5. Design changes, EIS clarifications and additional information

5.1 Design changes

NORTHERN SYDNEY FREIGHT CORRIDOR

EPPING TO THORNLEIGH

REVISED ETTT CONSTRUCTION IMPACT AREA PLUS VEGETATION COMMUNITIES AND RELEVANT HERITAGE ITEMS

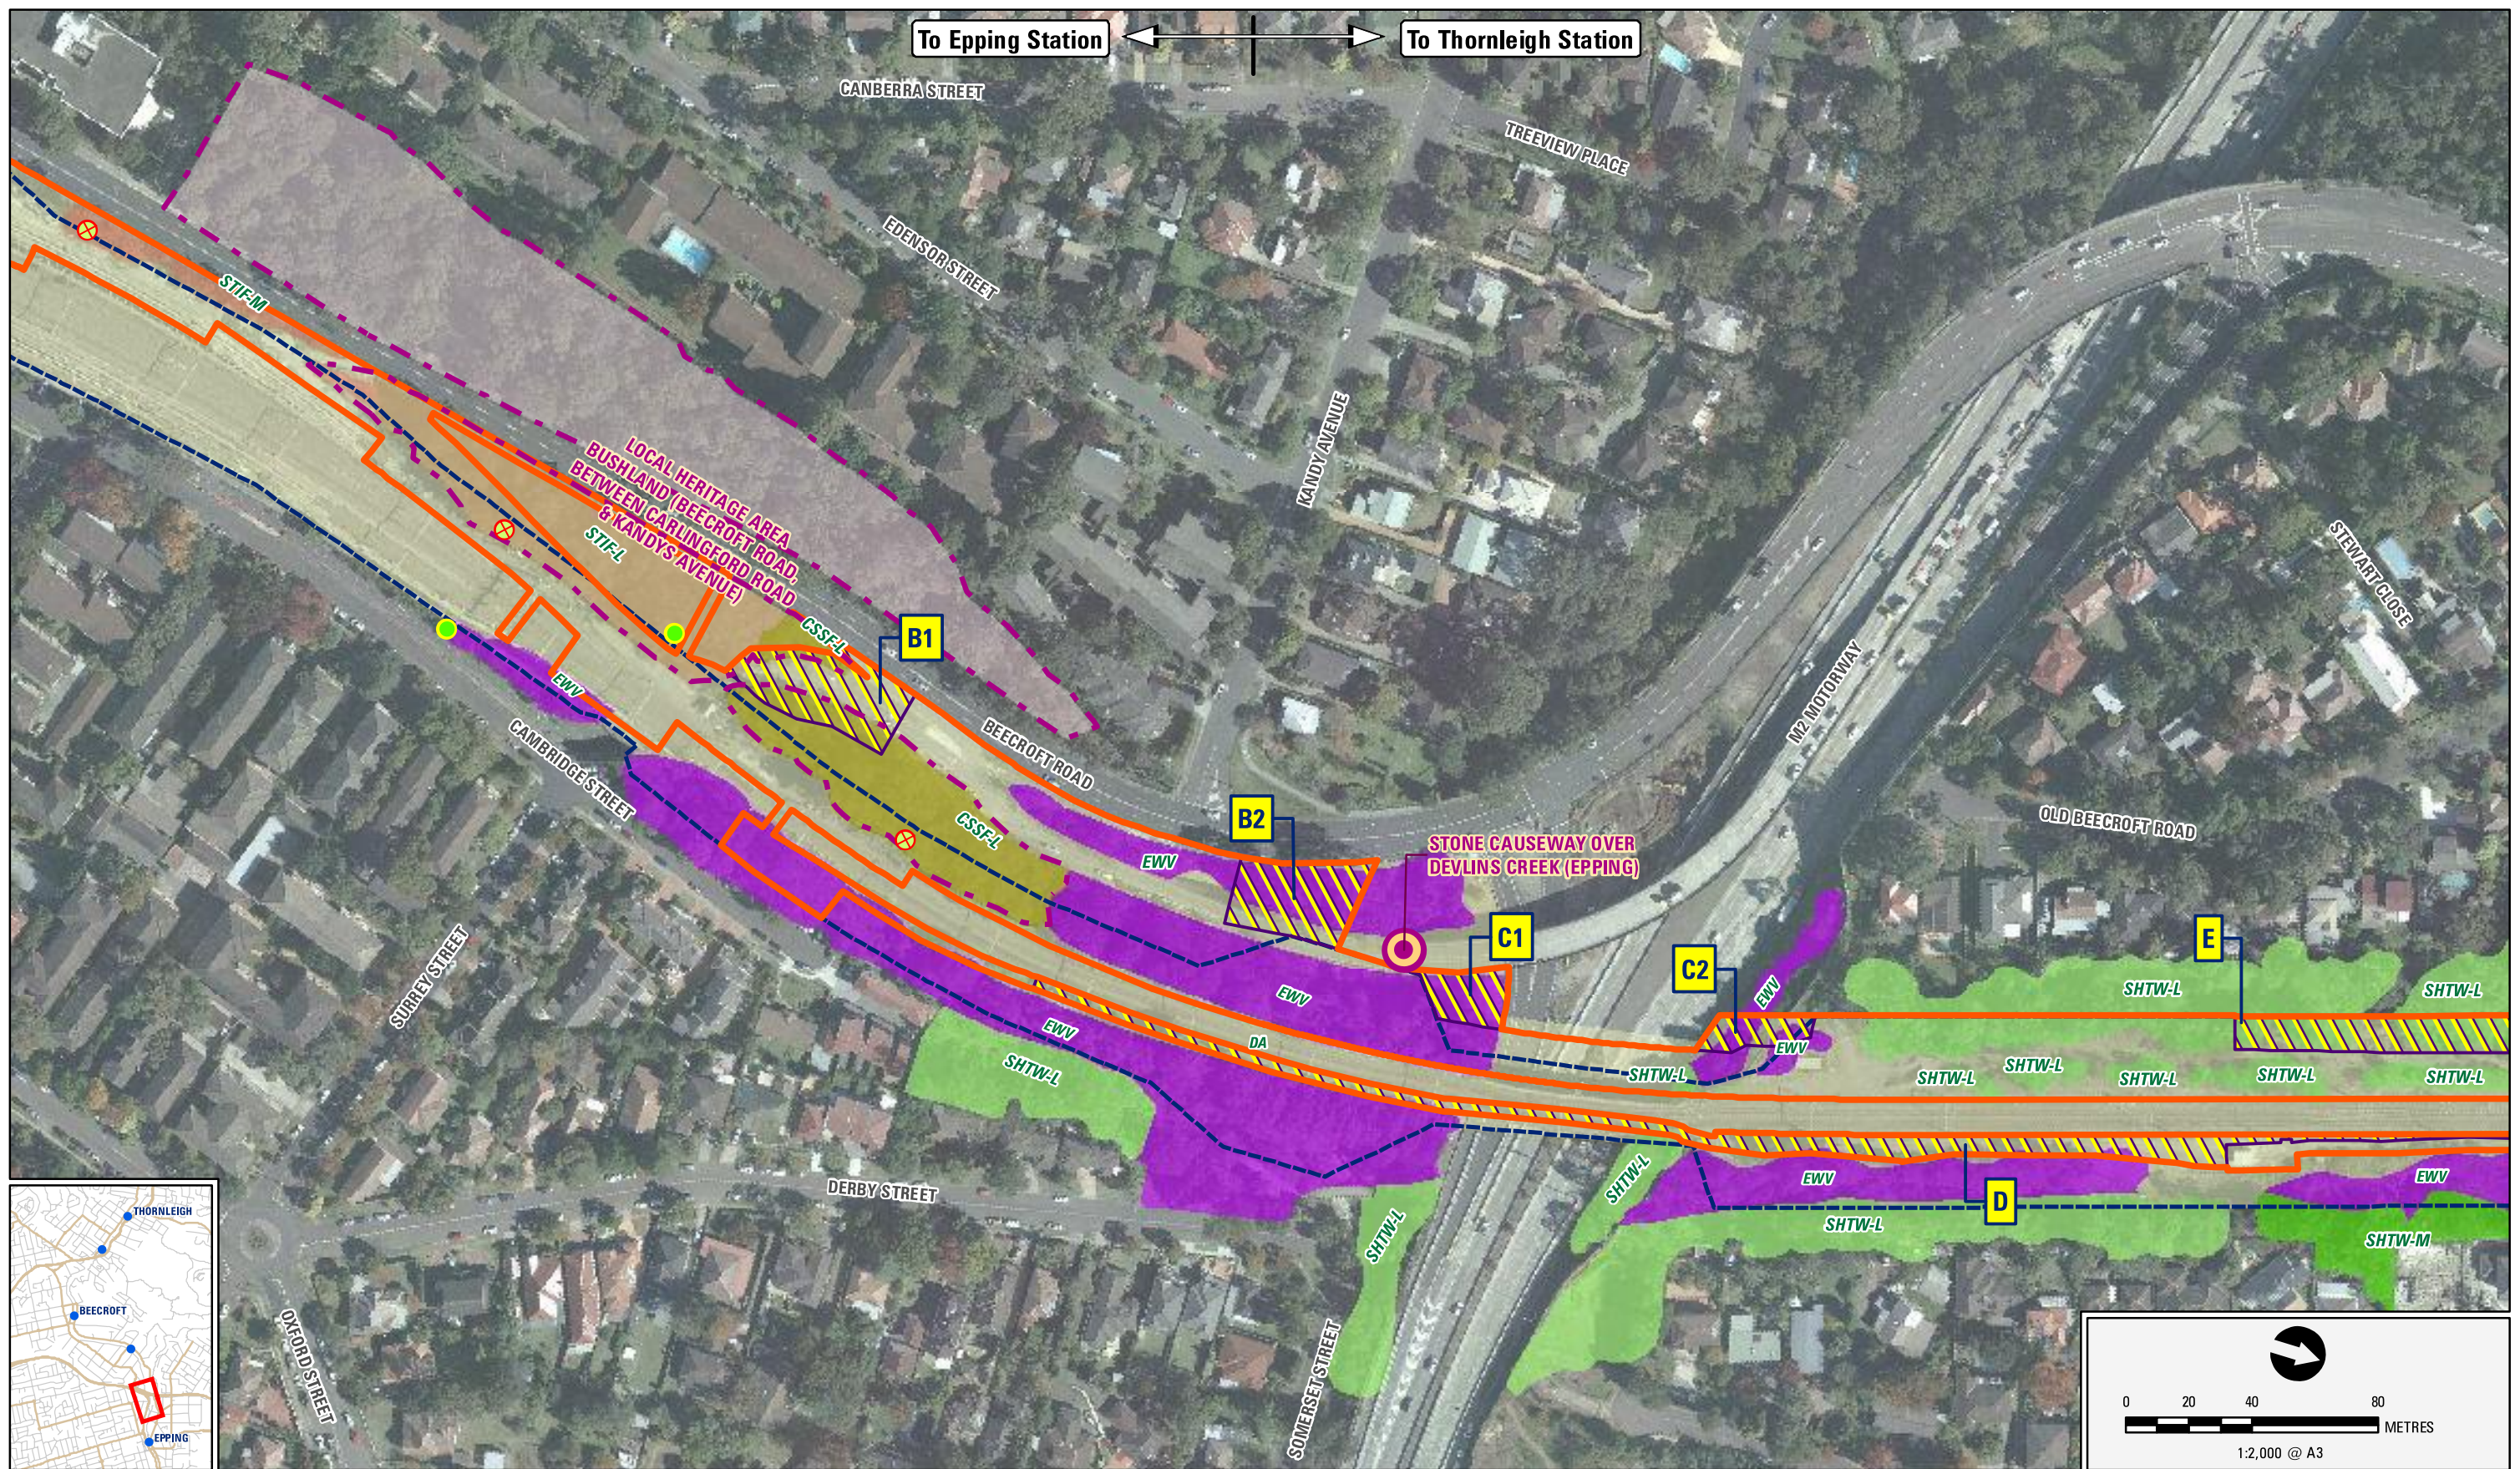
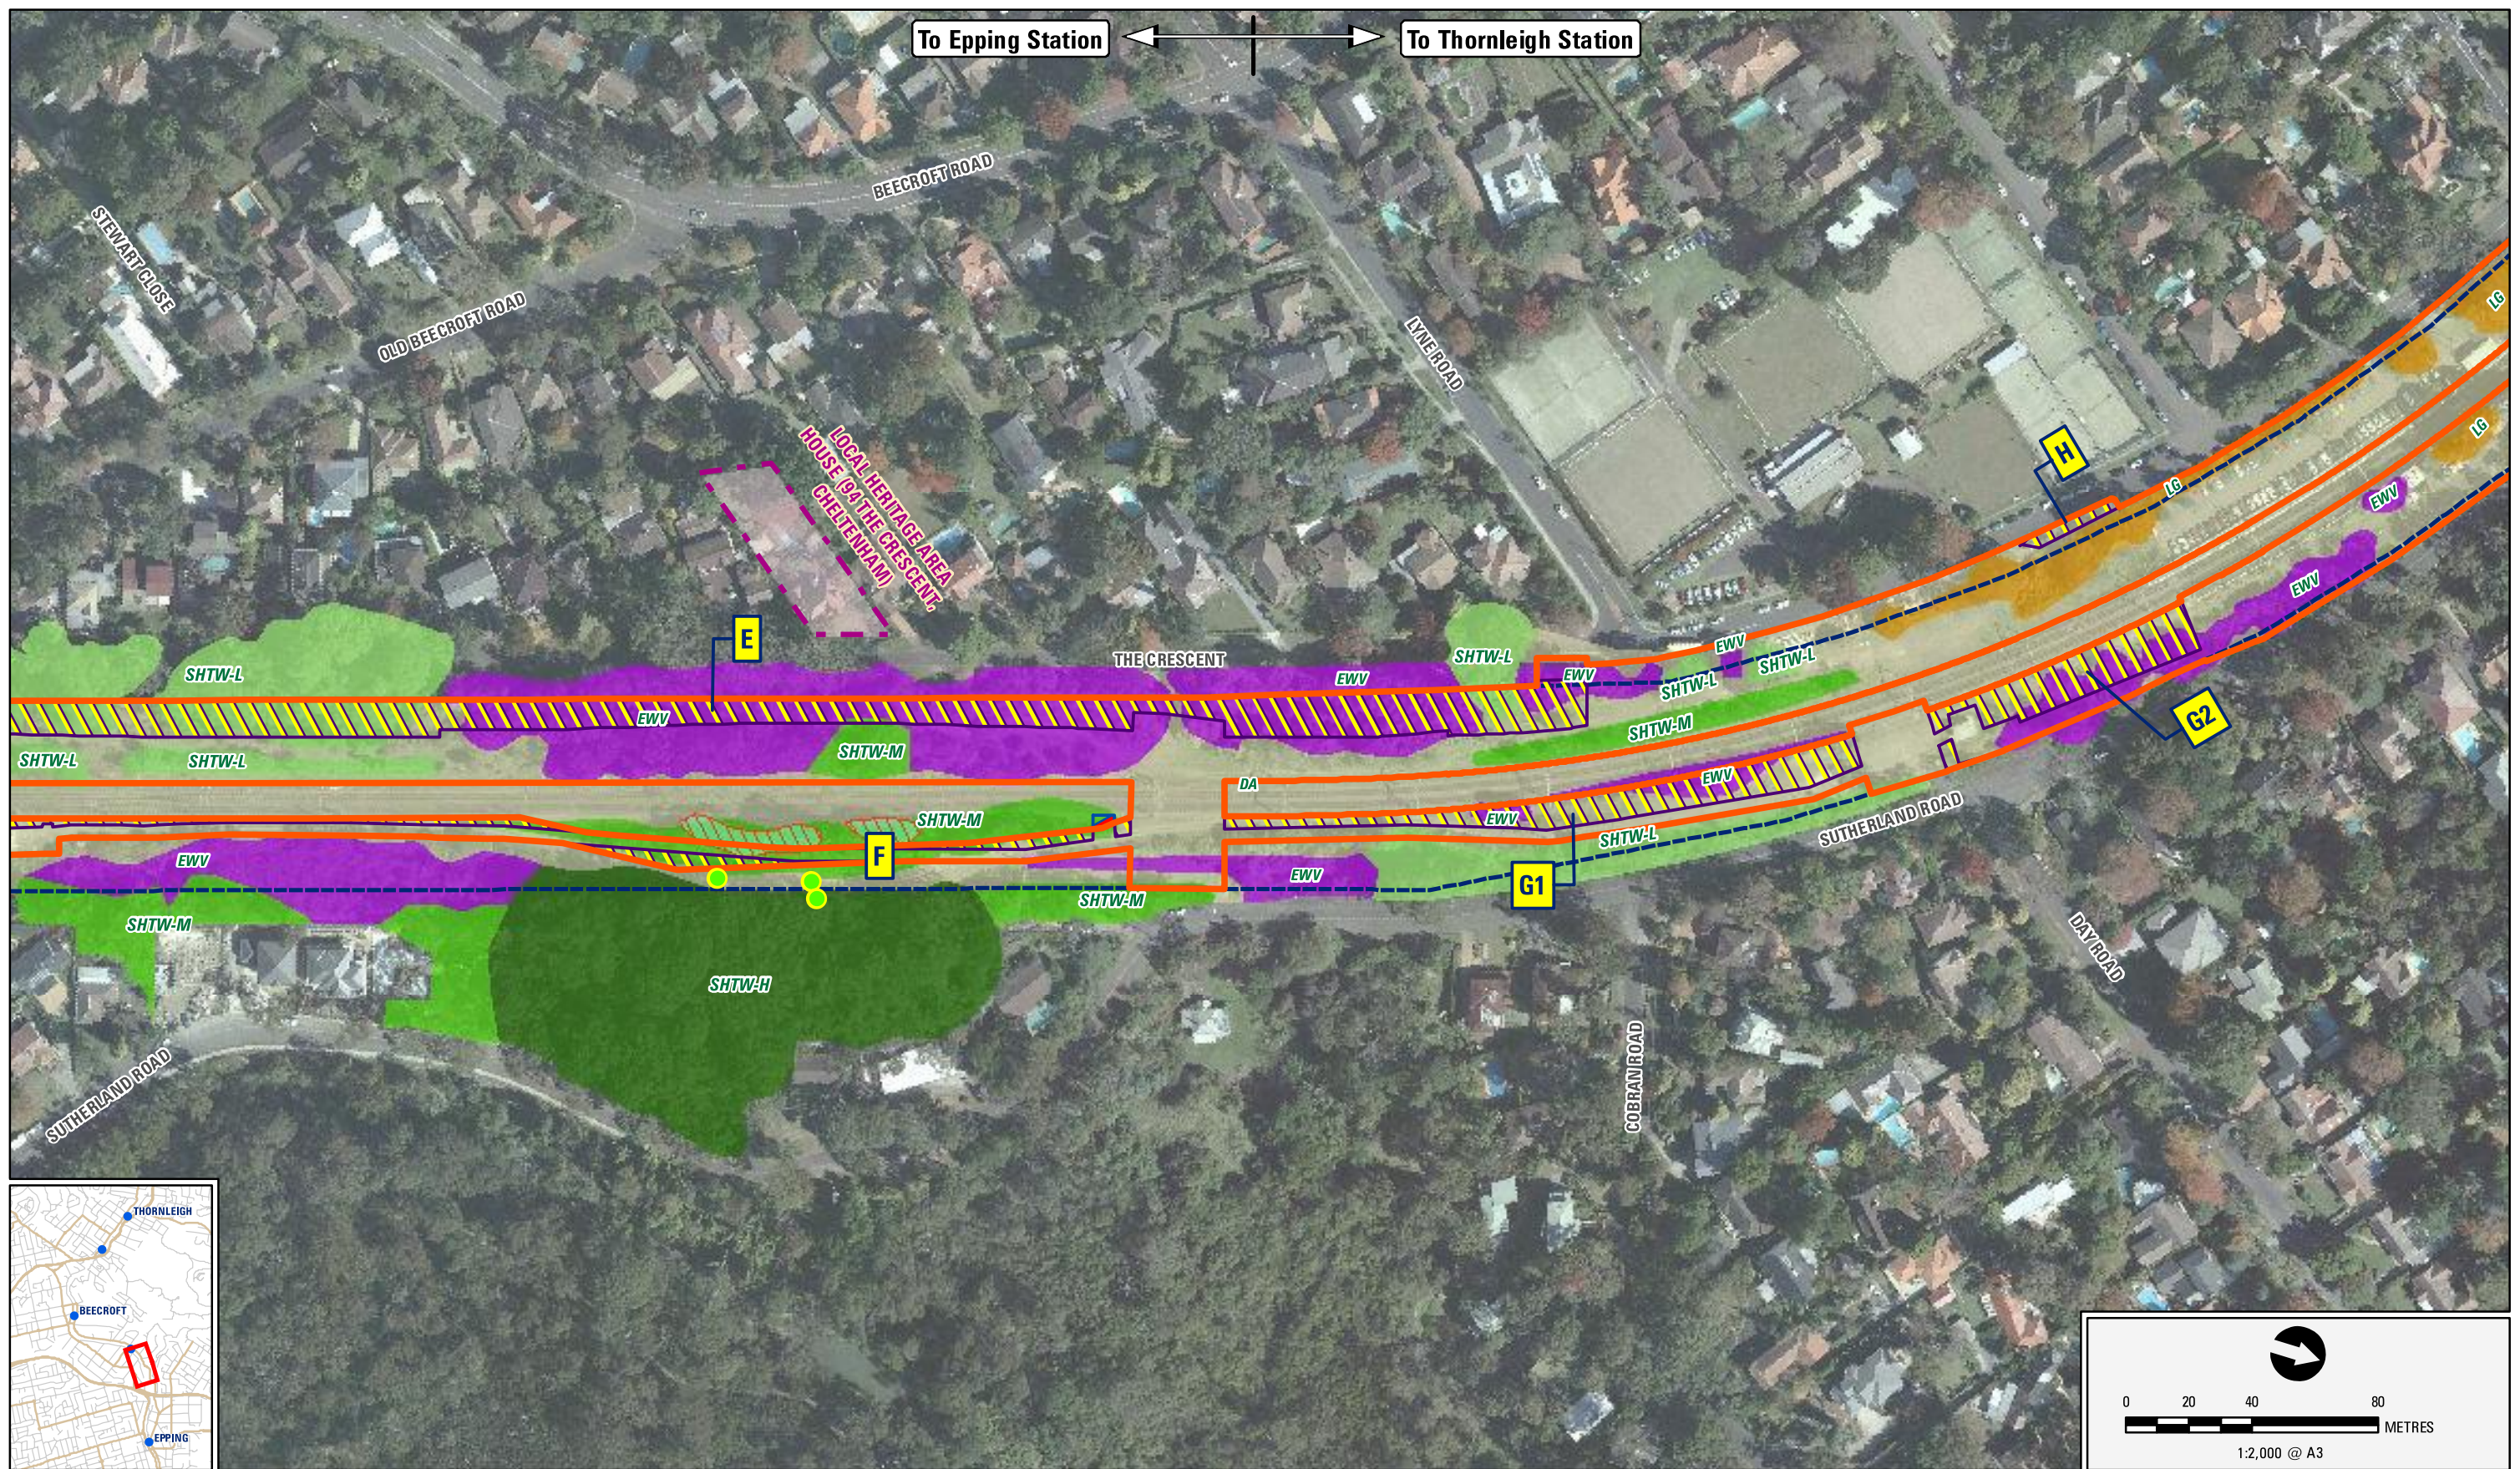
The construction impact area for the ETTT proposal, as shown in Figure 5.2 of the EIS, has been amended in various locations based on a review of constructability requirements. An outline of the proposed changes in construction impact area is provided in Table 5.1. A summary of the potential change in impact of the ETTT proposal as a result of each change is also provided in Table 5.1. The revised construction impact area for the ETTT proposal is shown in Figure 5.1.

Changed impact area	Description of proposed change	Summary of potential impacts
A	General work area increase to allow for the connection of the proposed railway services to existing facilities.	Increase in vegetation clearing and associated visual amenity impacts.
B1 and B2	Work area increased (onto Government owned land) to provide sufficient space for construction works, including the construction of the proposed viaduct and rail bridge crossing over the M2 Motorway and the delivery/storage of construction materials.	Increase in vegetation clearing and associated visual amenity impacts. Potential minor impact to heritage listed 'Bushland – Road reserve (between Carlingford Rd and Kandy Avenue)' (Hornsby LEP I 357) as a result of B1. Potential impact to the convict-built stone causeway crossing Devlins Creek (listed on Hornsby LEP) as a result of B2.
C1 and C2	General work area increase to provide additional area for access and construction of the proposed rail bridge crossing over the M2 Motorway.	Increase in vegetation clearing and associated visual amenity impacts. Potential impact to the convict-built stone causeway crossing Devlins Creek (listed on Hornsby LEP) as a result of C1.

D	Increase in trenching or installation of galvanised steel troughing for the connection of railway services between areas north and south of the M2 Motorway.	Increase in vegetation clearing and associated visual amenity impacts.

Changed impact area	Description of proposed change	Summary of potential impacts
E	Widened impact area to facilitate the establishment of a general work area. Area required for additional laydown, materials storage, construction of cuttings, establishment of a haul road for the removal of spoil, as well as to provide access for launching the structure of the proposed rail bridge crossing over the M2 Motorway.	Increase in vegetation clearing and associated visual amenity impacts. Area located adjacent to 'Ashby', a heritage listed house at 94 The Crescent, Cheltenham (Hornsby LEP I 297). Potential reduction in screening vegetation along the road reserve.
F	Modification to the combined services route (CSR).	Increase in vegetation clearing.
G1 and G2	General works area increase for a new power room, radio antenna and equipment room, and backup power supply.	Increase in vegetation clearing and associated visual amenity impacts.

H	Impact area widened to property boundary.	Nil.
I	General works area increase to facilitate construction of a new railway services pit and connection with public utilities/services.	Increase in vegetation clearing and associated visual amenity impacts.
J	Reduction in impact area due to the review of constructability requirements.	Reduction in vegetation clearing and associated visual amenity impacts.
K	Reduction in impact area due to the reduced clearance required at construction access gates.	Reduction in vegetation clearing and associated visual amenity impacts.
L	Reduction in impact area due to the reduced clearance required at construction access gates.	Reduction in vegetation clearing and associated visual amenity impacts.
M	General works area increase to facilitate construction of a new railway services pit and connection with public utilities/services.	Increase in vegetation clearing and associated visual amenity impacts.

O	Reduced area to reduce impacts on Beecroft Station Gardens and playground.	Reduction in vegetation clearing and associated visual amenity impacts.
P	Optimised car parking area to reduce impact area without reducing the number of car parking spaces to be provided.	Reduction in vegetation clearing and associated visual amenity impacts.
N	General works area increase to facilitate construction of a new railway services pit and connection with utilities.	Increase in vegetation clearing and associated visual amenity impacts.
Q	Increased construction impact area for the establishment of the combined services route and pits. Increase in trenching for services to facilitate construction of new pits and connections to railway services.	Increase in vegetation clearing and associated visual amenity impacts. However, impacts would be mostly confined to existing access roads within the rail corridor.
R	Increase in construction impact area due to a refinement of the new high voltage cable route	Increase in vegetation clearing and associated visual amenity impacts.

S	General works area increase to facilitate construction of additional services as well as facilitating construction access from Hampden Road, if required.	Increase in vegetation clearing and associated visual amenity impacts. However, impacts would be mostly confined to existing access roads within the rail corridor.
T	General works area increase for the installation of additional railway services.	Increase in vegetation clearing and visual amenity impacts
U, V and W	Reduction in impact area due to the reduced clearance required at construction access gates.	Reduction in vegetation clearing and associated visual amenity impacts.
